# Memo

Your ref: SD25238

## A4173/A46 PITCHCOMBE JUNCTION Installation of Traffic Signals – Initial Comments

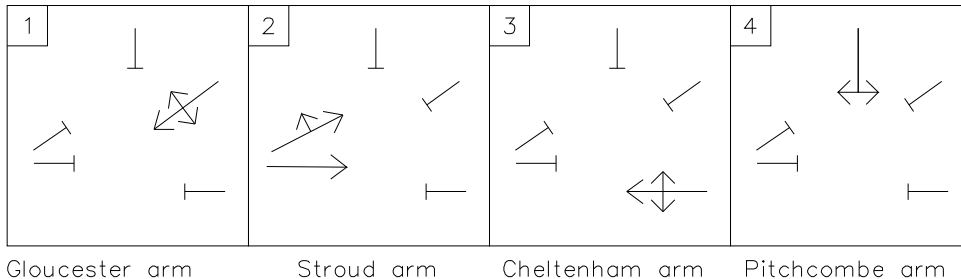
The safest method of control is to allow each arm of the junction to receive green time in turn, so that all turning movements can be carried out without conflict. However, as there are few turning movements at the junction, it is highly likely that this strategy will not be popular with the public, and the junction will be criticised as inefficient. There is a danger of driver frustration and anti-social driving behaviour, such as red light running, tail-gating etc and although the junction will reduce the number of right turning accidents, there is a possibility that the number of shunts will increase.

The current speed limit on all arms of this junction is 50mph. TAL2/03 recommends that vehicles should not be allowed to gap accept across traffic where the 85%ile speeds are 45mph or more. It is also not good practise to allow vehicles to gap accept where there are multiple lanes to be crossed. These recommendations should be followed due to the existing number of right turn accidents at the site. Therefore, either the 85%ile speed must be reduced to allow gap accepting right turns or it must be possible to separately signal right turn movements if ahead movements from separate arms are to move at the same time. The Stroud arm is already a two lane approach, but Gloucester arm and Cheltenham arm are both single lane. Existing verge and footway would need to become carriageway to allow additional lanes to be installed on both of these arms, even if the bus bay were incorporated on the Gloucester arm. This would be costly due to road lighting and possible statutory undertakers equipment diversions, and first indications are that this would not give a good alignment through the junction for the ahead movements from the Cheltenham arm and Stroud arm. Traffic calming would be needed together with a speed limit reduction if the 85%ile speeds are to be lowered for gap acceptance to be feasible. The measures would need to be agreed and proven satisfactory prior to the junction signalisation works.

The issues could be overcome by banning the right turns and U turns. However, a suitable alternative route would need to be identified and signed that would be capable of allowing all types of vehicle access without causing an excessive diversion for drivers, and in particular, local people. 'Wragg Castle Lane' joins A38 Cheltenham to A4173 Gloucester routes and would allow access to Pitchcombe via a turning from A4173 before the junction. However, as a 'lane' it is unlikely that the route will be suitable for some vehicles. Wragg Castle Lane is located approx 1000m east of the junction on the A38 Cheltenham arm.

## 2. Gap accepting right turns and U turns

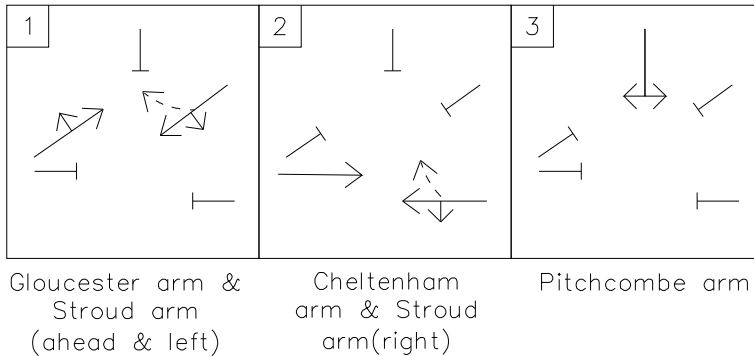
The junction works well with plenty of reserve capacity for future growth in traffic volumes on a relatively short cycle time in both peak periods. The mean/max queue for the right turn lane on the Stroud arm at 10pcu's in the AM peak and 8pcu's in the PM peak should not block ahead traffic as the existing lane can accommodate approx 15pcu's. Similarly, the Stroud ahead and left lane traffic queue at 8.6pcu's in the AM peak and 6.7pcu's in the PM peak would not prevent vehicles wishing to turn right from entering their lane. The actual numbers of right turners and U turners on the Cheltenham and Gloucester arms are so low that it is unlikely that more than one vehicle will be waiting to make these moves at any given time and initial sketching of possible junction layouts indicate that sufficient waiting areas can be provided in the junction design to allow other traffic to pass those waiting to complete their manoeuvres in gaps. However, it must be possible to reduce 85%ile speeds to less than 45mph for this option to be viable.

### 3. Fully signalised right turns and U turns

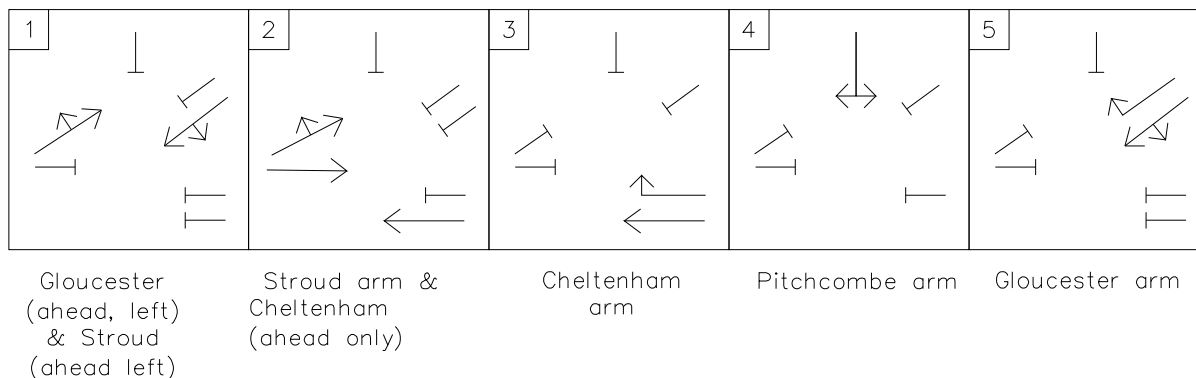
The junction performs well, even when each right turn stage and the Pitchcombe arm is called each cycle, which is unlikely to happen in actuality. Should the right turn stages not be called, the junction will operate with similar results to those shown with gap acceptance (see 2). The average cycle times are relatively low and there is spare capacity to cope with future growth in traffic volumes. However, to achieve the right turn lanes, there will need to be considerable carriageway widening, diversion of statutory undertakers apparatus and street lighting. The initial findings also show that the alignment for drivers through the junction may not be very good and improvement may be difficult due to the topography of the area.
